ADDENDUM NO. 1

RE: Downtown Sidewalk Improvements – City of Dekalb, Texas

ADDENDUM DATE: July 16, 2024

DEMO PLAN

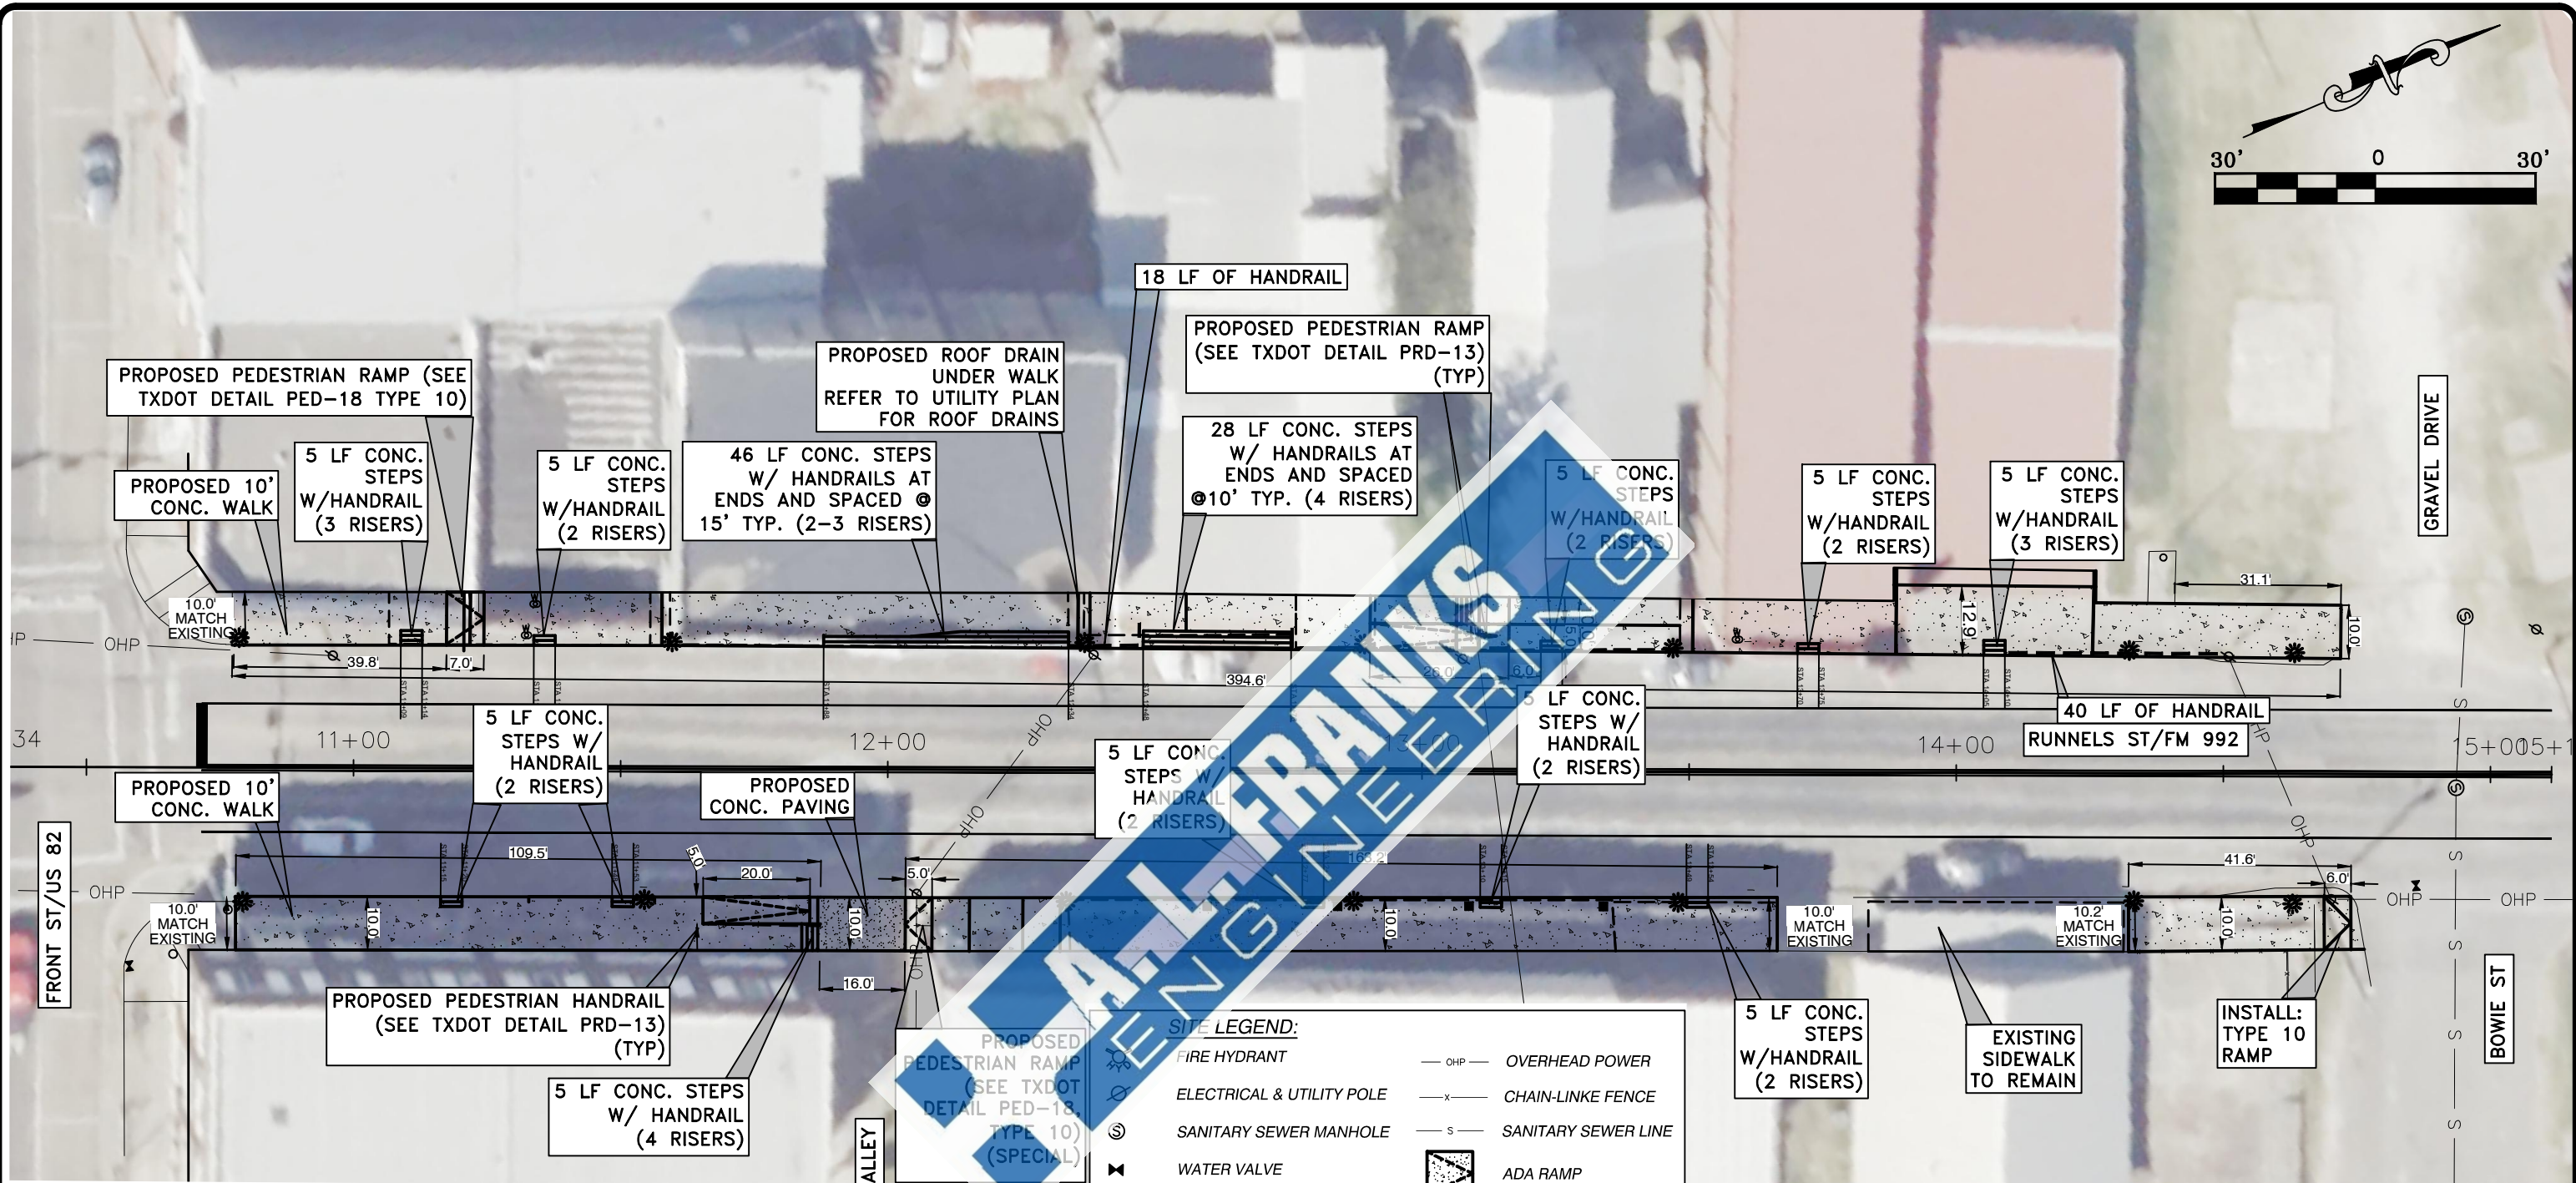
2-2-24	1-UPDATED PER CITY COMMENT	CJM
5-1-24	2-UPDATED PER TXDOT COMMENT	CJM
7-16-24	3-METER NOTE UPDATED	CJM
Date	Revision	By

VARIABLE WIDTH SIDEWALK.....	760 SY
HANDRAILS.....	215 LF
PLANTER BOX.....	3 EACH
LAMP POST.....	4 EACH
METAL BENCH.....	2 EACH
ASPHALT PAVING.....	18 SY
METER REMOVAL.....	3 EACH
DRAIN REMOVAL.....	9 EACH

Job No.:	DK-01-23
Scale:	N/A
Date:	7/2024
Sheet	9

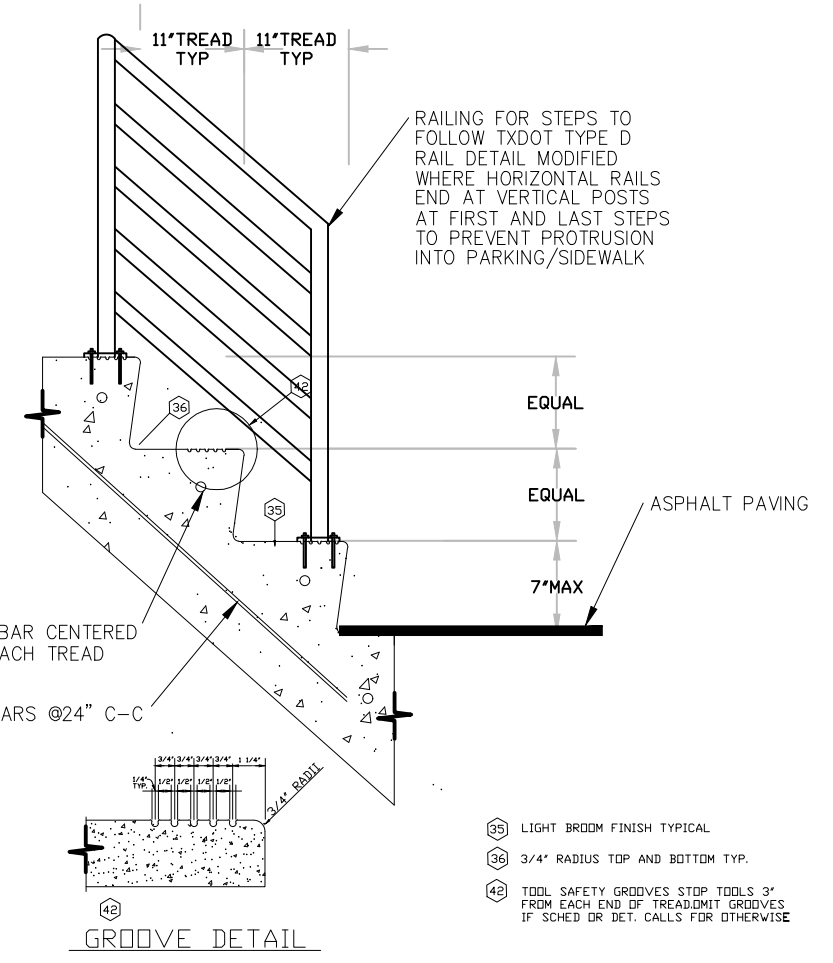
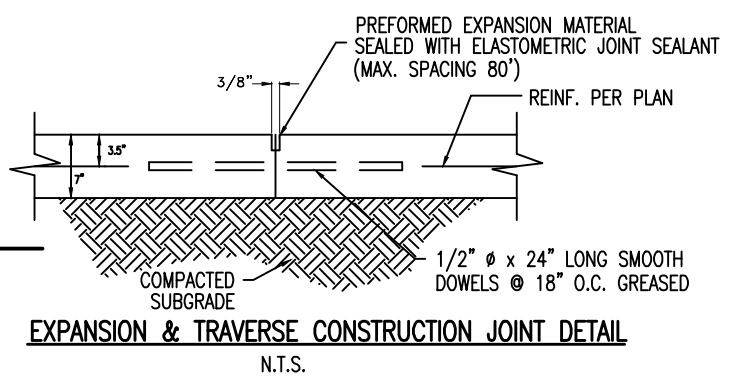
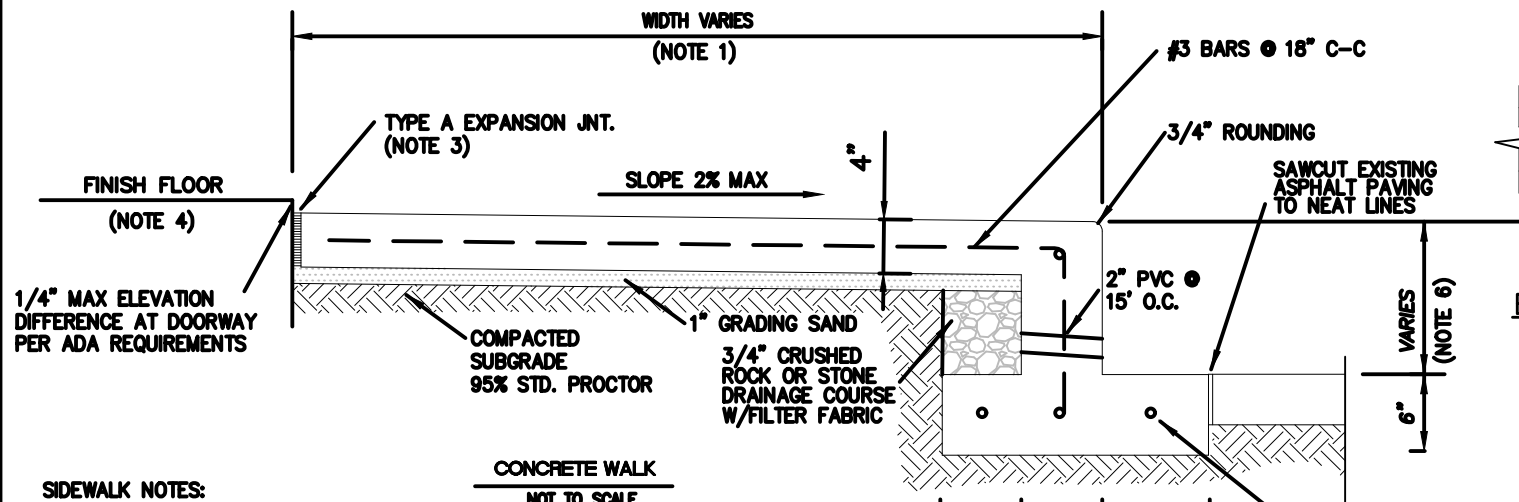
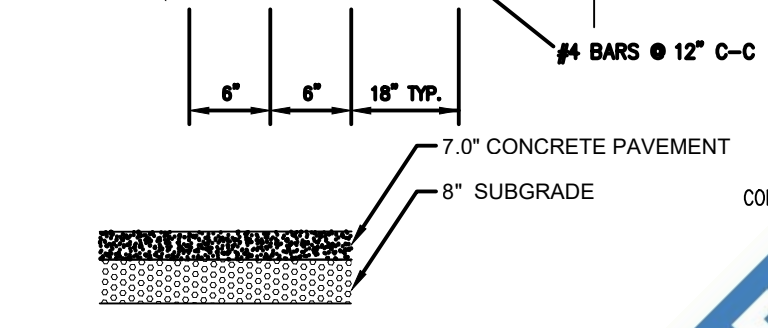
- **Bid Proposal: Remove and Replace Bid Proposal with attached.**
 - a. **Item added for removal of sidewalk drains**
 - b. **Existing meter removal increased**
 - c. **Type D railing clarified to match plans**
- **Plan Set: Remove and Replace Plan Set with attached.**
 - a. **Meter removal clarified on northwest end**
 - b. **Rebar for concrete walk detail clarified to be #3 bars at 18”**

2-2-24	1-UPDATED PER CITY COMMENT	CJM
5-1-24	2-UPDATED PER TXDOT COMMENT	CJM
7-16-24	3-WWM REMOVED FROM WALK DETAIL	CJM
Date	Revision	By
